## 新潟県中越沖地震による柏崎刈羽原子力発電所への影響に関する 国際原子力機関（IAEA）のフォローアップ調査団報告書の公表について

平成20年3月4日  
経済産業省  
原子力安全・保安院

## IAEA柏崎刈羽原発フォローアップ調査団報告書について

**A2-07**NPP: **KASHIWAZAKI-KARIWA NPP**Unit: **UNITS 1 TO 7**Assessment Area: **A.2 – PLANT BEHAVIOUR – STRUCTURES, SYSTEMS AND COMPONENTS**Finding Title: **A2-07 –INTEGRITY ASSESSMENT OF SYSTEMS AND COMPONENTS**

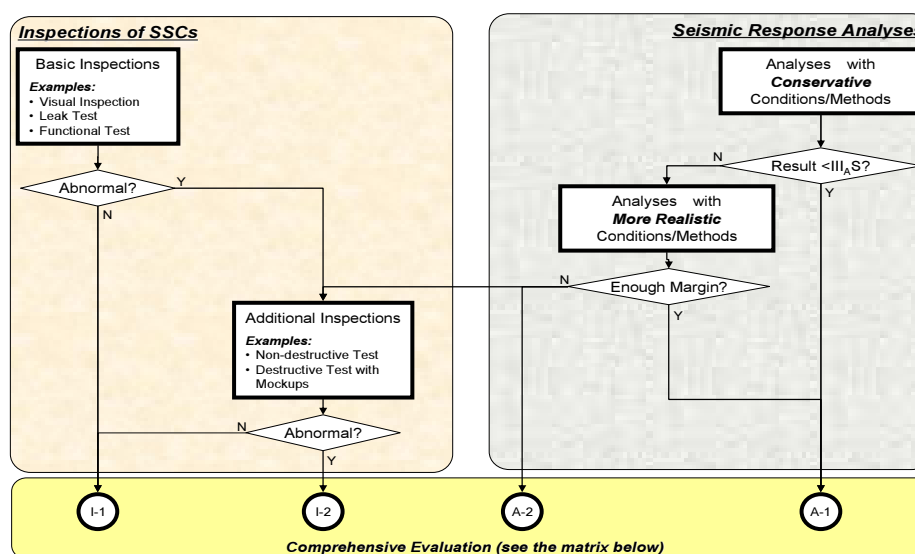
- During discussions with NISA and TEPCO, it was understood that the integrity assessment plan developed by TEPCO uses both analysis and inspection to assess the integrity of SSCs. The use of both inspection and analysis to assess the integrity of components leads to separating the components into four basic categories as shown above.

1. While discussing the analytical portion of the integrity evaluation plan developed by TEPCO, it was noted that the simple models used by TEPCO in its analysis –following the same criteria adopted at the time of the original design- may not always provide answers or explanations to the effects observed as consequence of the earthquake and may not always provide conservative results. This topic was discussed with the Japanese counterparts who agreed with the observation.

2. It was noted that some of the analyses presented by TEPCO used a set of assumptions, criteria and methods that may need to be reviewed, should the plant be re-evaluated to a higher seismic input. It was suggested to TEPCO that it would be better to adopt a more realistic set of assumptions, methods, modelling and acceptance criteria for these analyses, in order to proceed consistently during the entire re-evaluation process.
